CONNECTION ASSESSMENT & APPROVAL PROCESS

ASSESSMENT SUMMARY

Project: Nickel Rim Mine Substation

CAA ID No. 2003-EX174

DIAGRAM 3

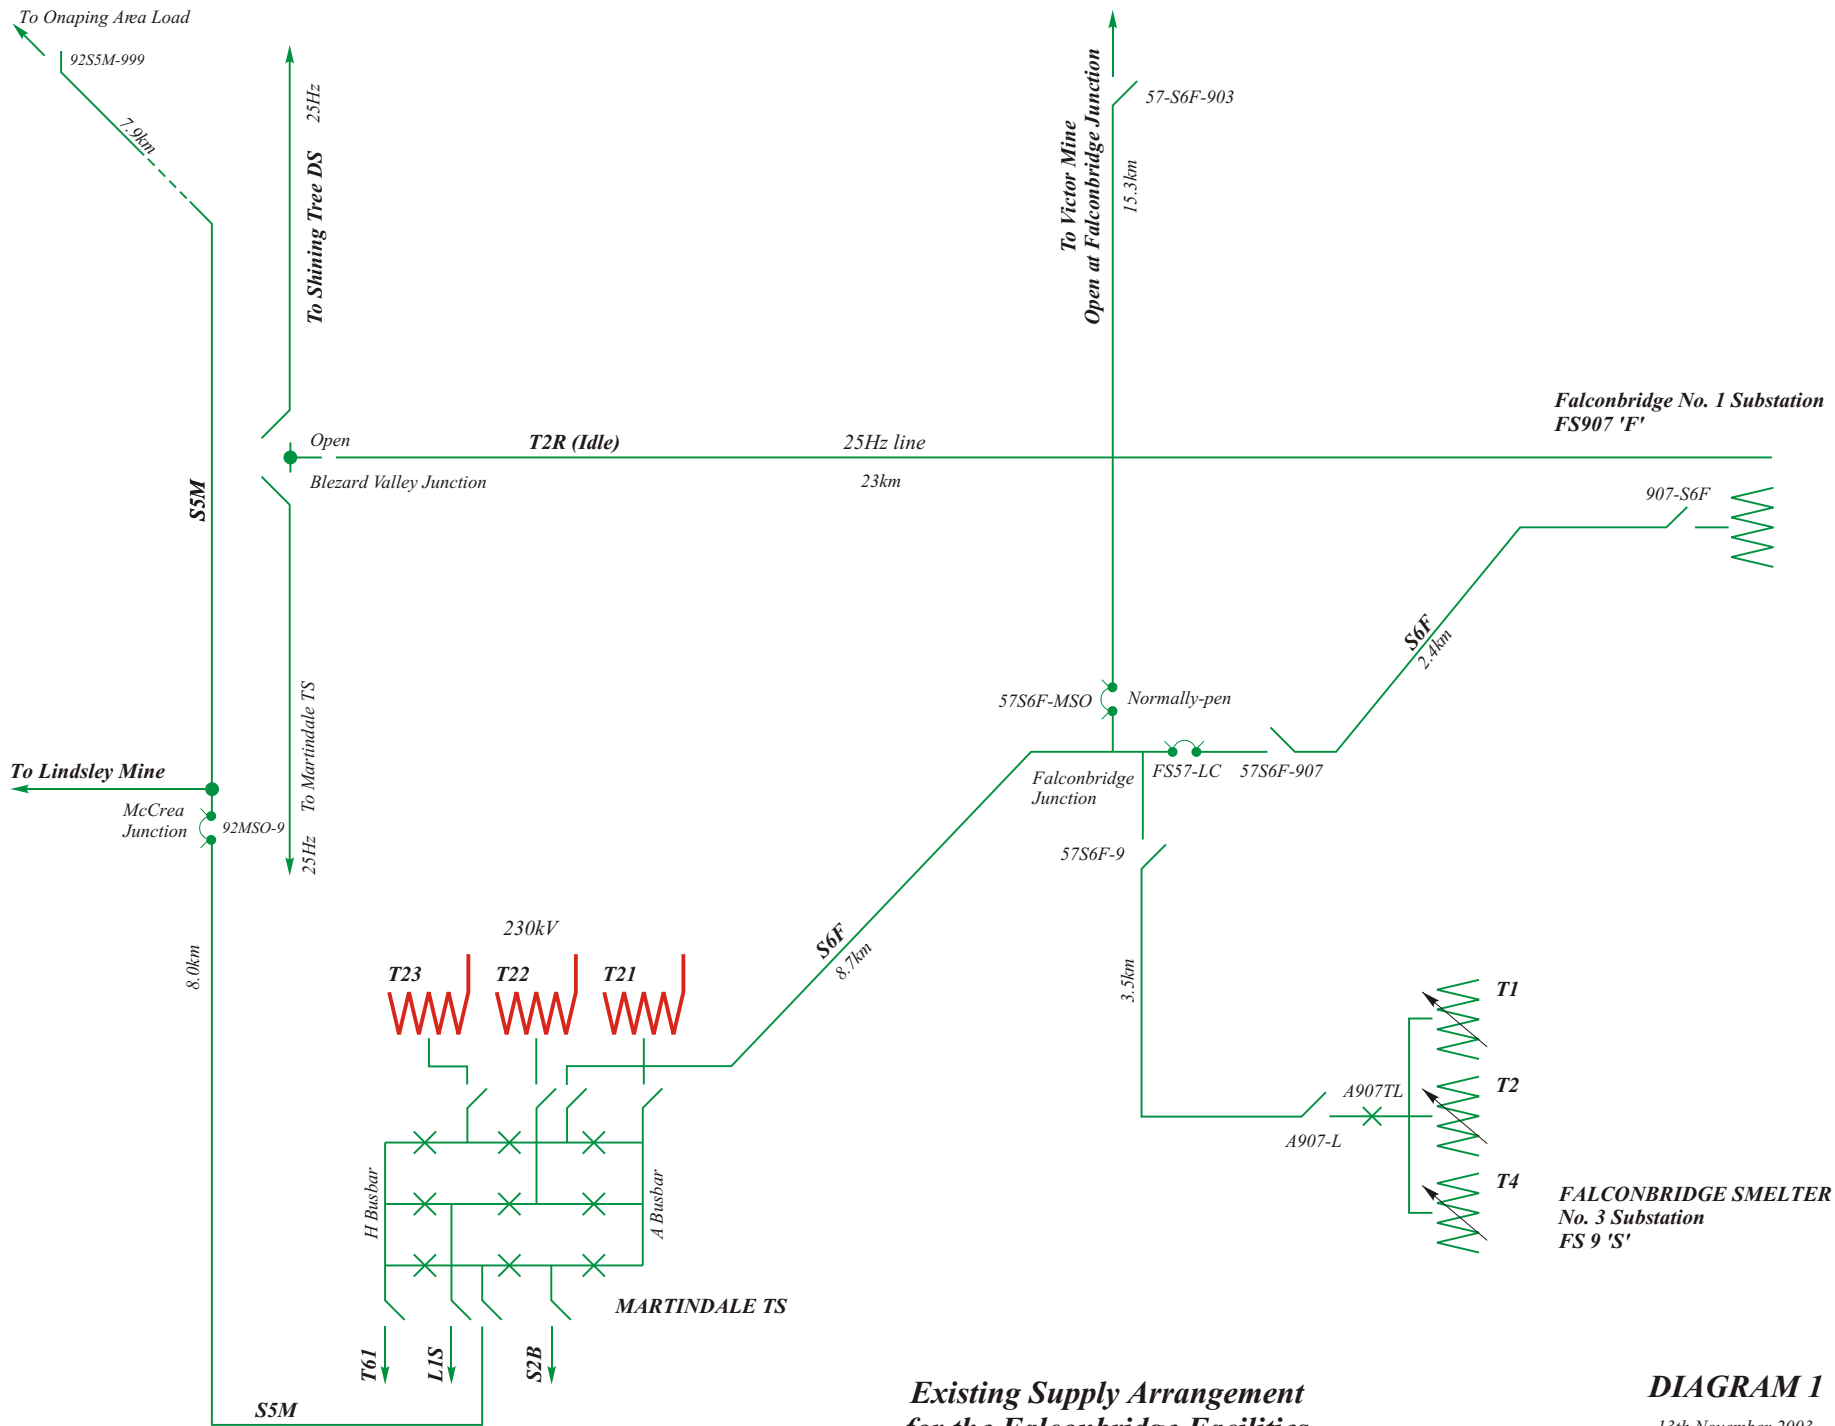
Diagram 3 shows the arrangement that has been proposed for establishing a supply to the new Nickel Rim Mine development.

Equipment Voltage Ratings:

Appendix 4.1 of the Market Rules details the voltage variation that equipment connected to the 115kV system must be able to accommodate.

For the majority of the system, this range is 127kV to 113kV. However, for northern Ontario, equipment has to be able to accommodate a maximum voltage of 132kV.

Clause 7.1.1 of Section 7 and Clause 1.1.2 of Schedule H in Appendix 1 of the Transmission System Code both state that:

Transformers shall have adequate under-load tap-changers to operate continuously within normal variations of the transmission system, as set out in the Market Rules (i.e. 132kV to 113kV), and to operate with a further transmission voltage variation of $\pm 6\%$ in emergencies.

1. All equipment installed at the Nickel Rim Mine Substation must be suitable for continuous operation at 132kV. Reference 2 of Appendix 4.1 of the Market Rules

2. The step-down transformers installed at the Nickel Rim Mine Substation must be suitable for operation over a voltage range of 132kV to 113kV, as defined in the Market Rules.
[This is expected to require the use of under-load tap-changers as stipulated in Clause 1.1.2 of Schedule H of the Transmission System Code, which is administered by the Transmitter (in this case, Hydro One).]

3. The new supply point is to be equipped with an automatic under-frequency load-shedding scheme.
This scheme is to have the capability to reject up to 35% of the load supplied from the new facility in response to a declining system frequency. The appropriate settings for the under-frequency load-shedding scheme will be provided by the IMO prior to commissioning of the new facilities.
Reference 2 of Appendix 4.3 of the Market Rules
[Alternatively, an equivalent amount of load at the other Falconbridge facilities supplied from circuit S6F could be included in the scheme.]

4. The load at the Nickel Rim Mine Substation must be maintained at a power factor of at least 0.90 (lagging) when measured at the high voltage side of the step-down transformers.
Reference 1 of Appendix 4.3 of the Market Rules.

DIAGRAM 5

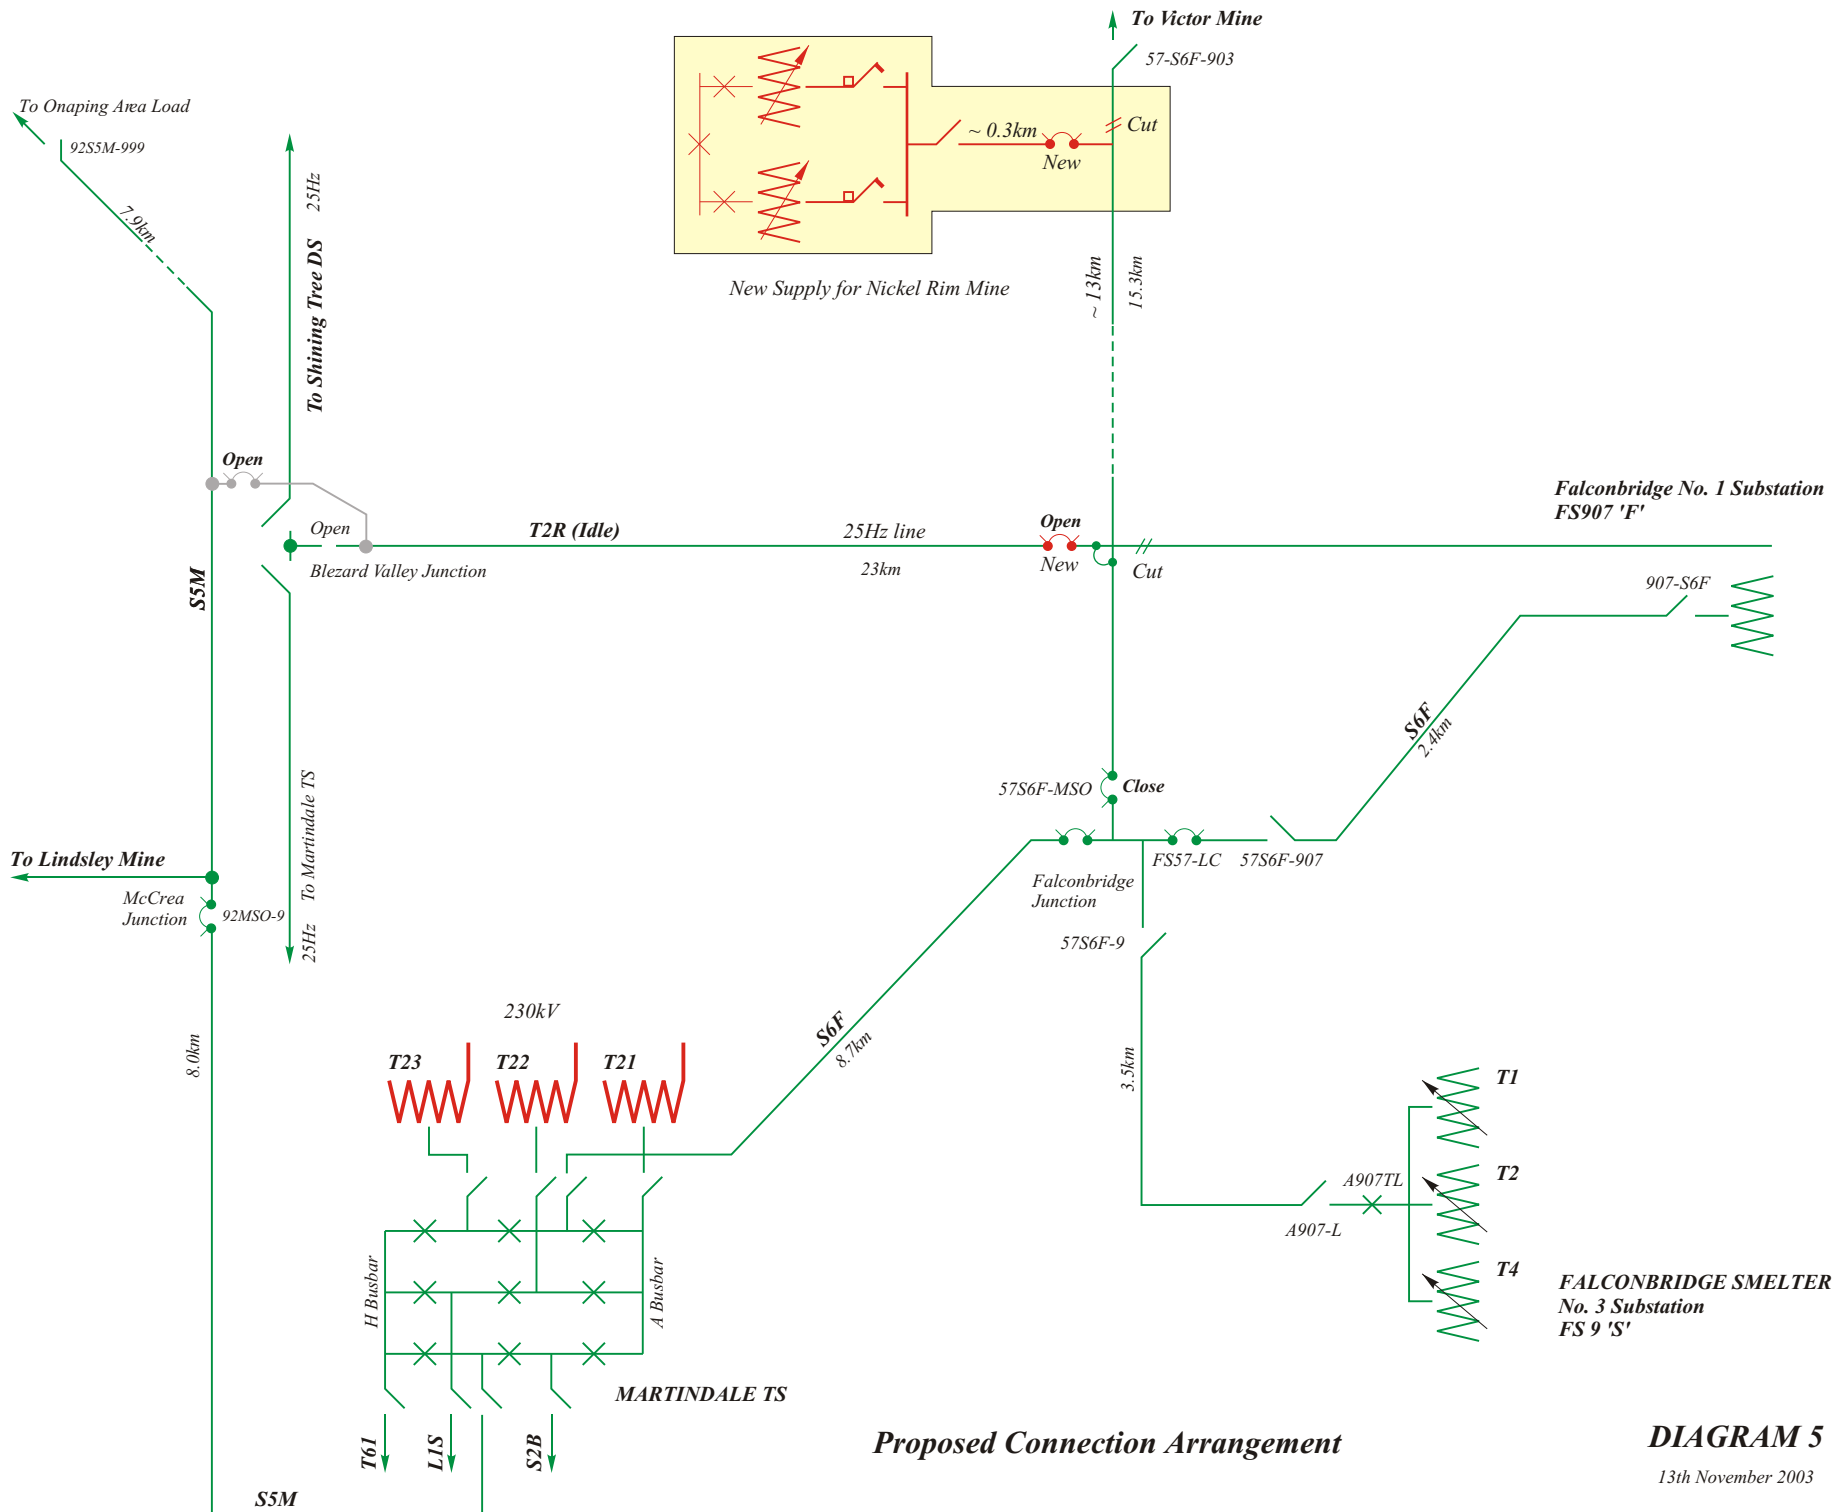
Should Falconbridge want to retain the capability to take a limited emergency supply from circuit S5M via the 'idle' section of the 25Hz circuit T2R then additional mid-span openers would need to be installed in circuit T2R at the junction point of circuits S6F and T2R, as shown in Diagram 5.

It would also seem prudent to include mid-span openers at this junction point in the 13km section of circuit S6F that is to supply the Nickel Rim Mine. This would facilitate the return to service of the sections of circuit S6F that supply the Falconbridge No.1 Substation and the Falconbridge Smelter No. 3 Substation whenever the section of circuit S6F to the Nickel Rim substation has to be removed from service.

The IMO therefore recommends that consideration be given to the installation of new mid-span openers at Falconbridge Junction in the following line sections:

- The section of circuit T2R to Blezard Junction
- The section of circuit S6F to the Nickel Rim Mine Substation

DIAGRAM 6

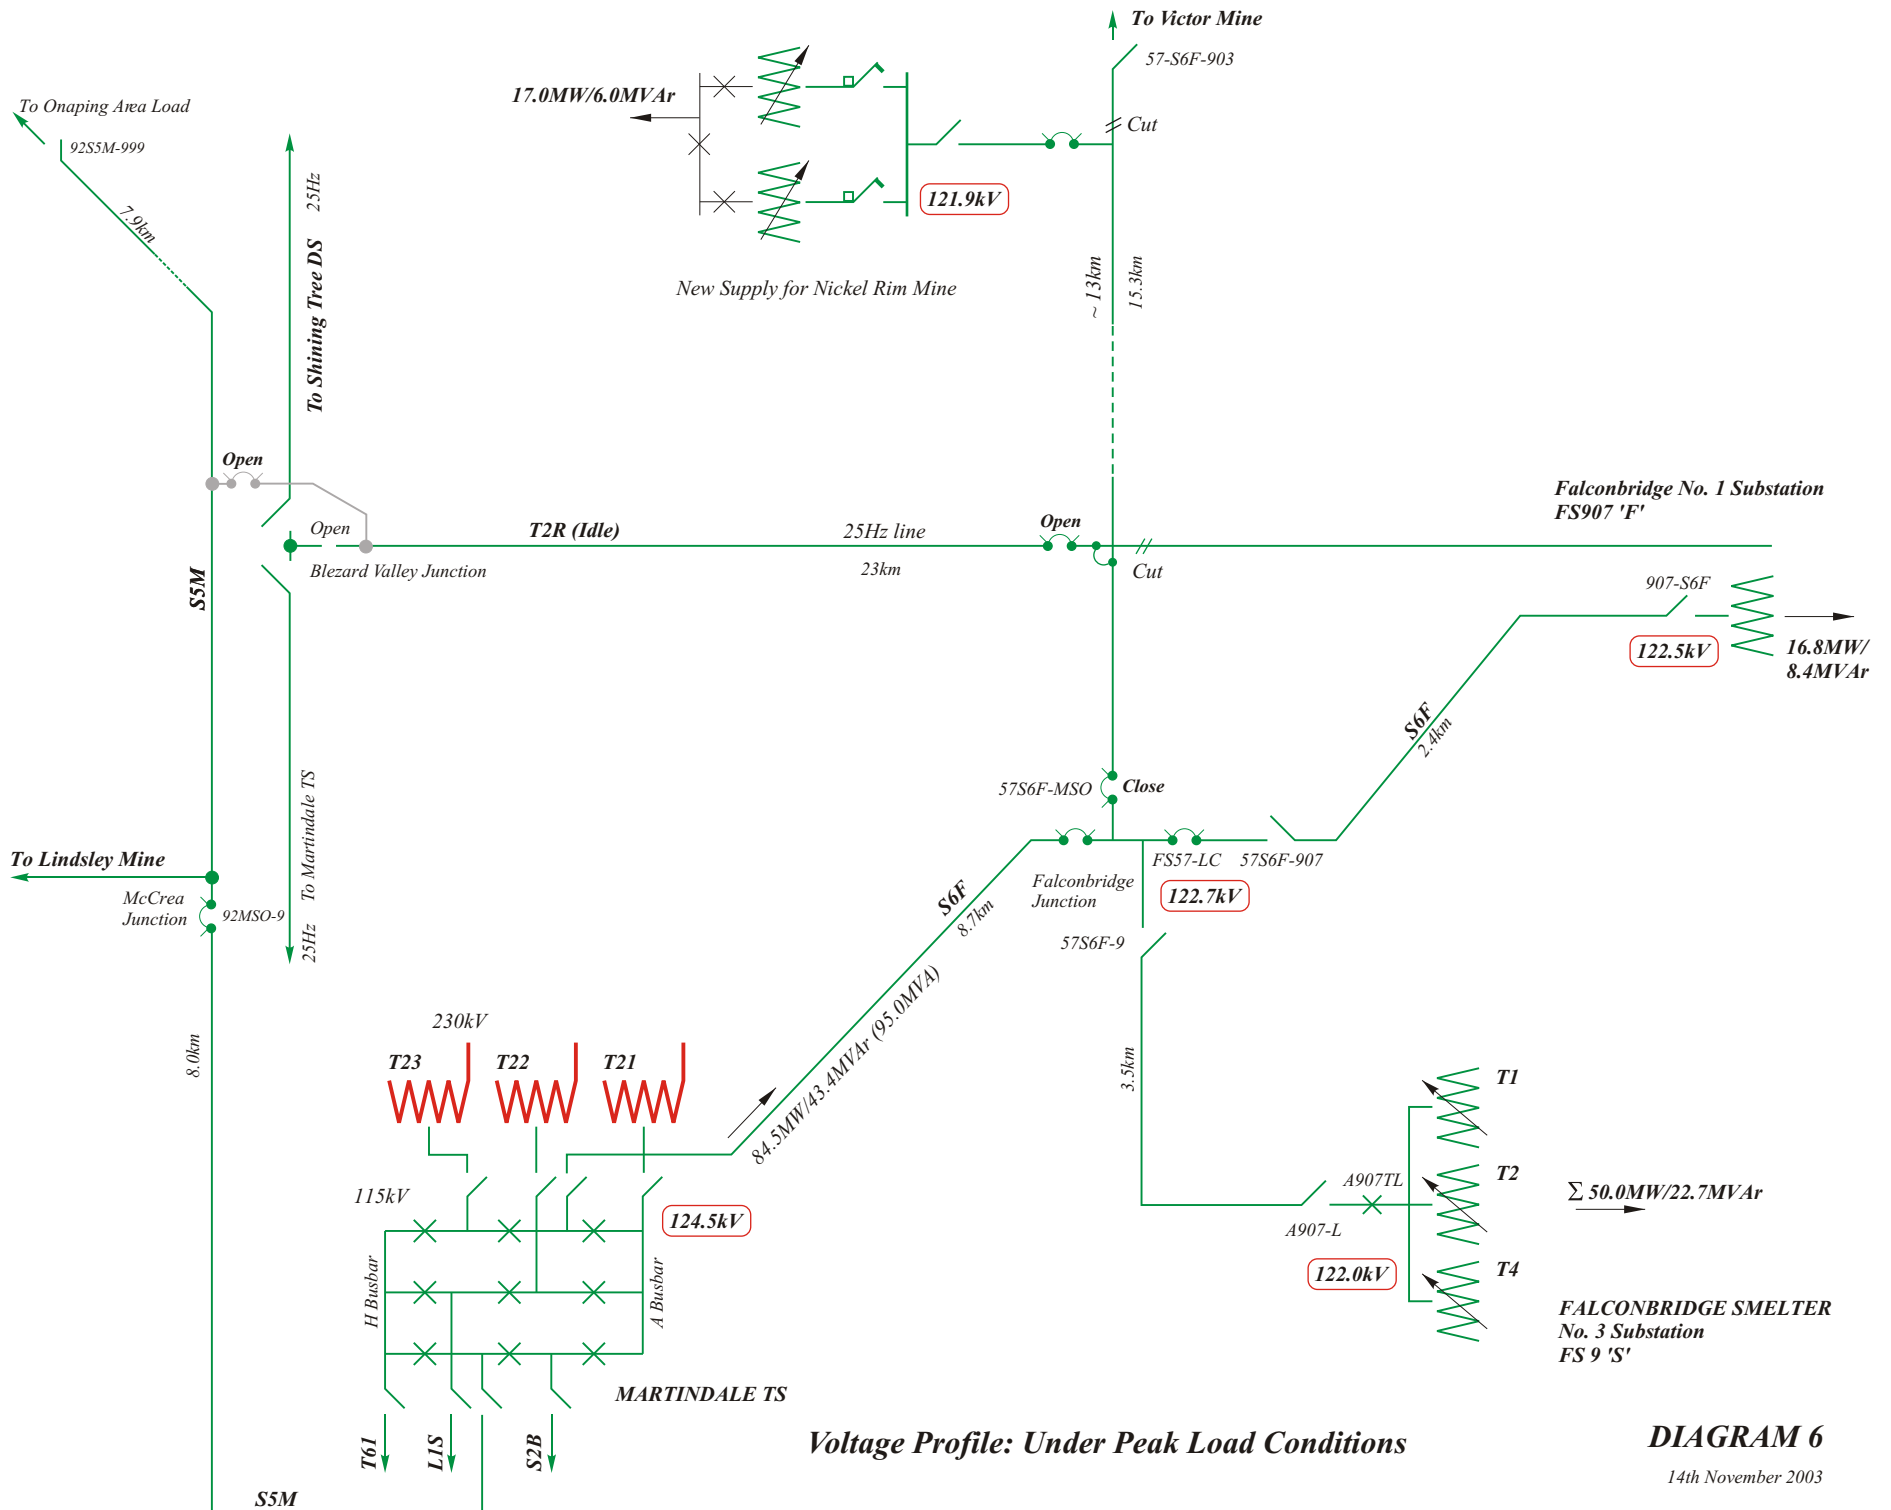
<i>Operating Condition</i>	<i>Flow on Circuit S6F from Martindale TS</i>	<i>Voltages</i>		<i>Diagram No.</i>
		<i>Martindale TS</i>	<i>Nickel Rim Substation</i>	
1. Peak Load Condition	95.0MVA	124.5kV	121.9kV	6
2. Light Load Condition (25%)	23.1MVA	126.3kV	125.8kV	7
3. Peak Load Condition, with a reduced 115kV voltage at Martindale TS	95.2MVA	121.3kV	118.6kV	8

For the limited range of studies that were performed, the voltage at the Nickel Rim Substation has been shown to vary from 118.6kV to 125.8kV. In practice, this variation is expected to be greater in response not only to the variation in the voltage at Martindale TS, but also to the load at the Falconbridge facilities supplied from circuit S6F.

The maximum loading on the section of circuit S6F between Martindale TS and Falconbridge Junction is shown to be approximately 95MVA. This would well below the 220MVA continuous rating for this section.
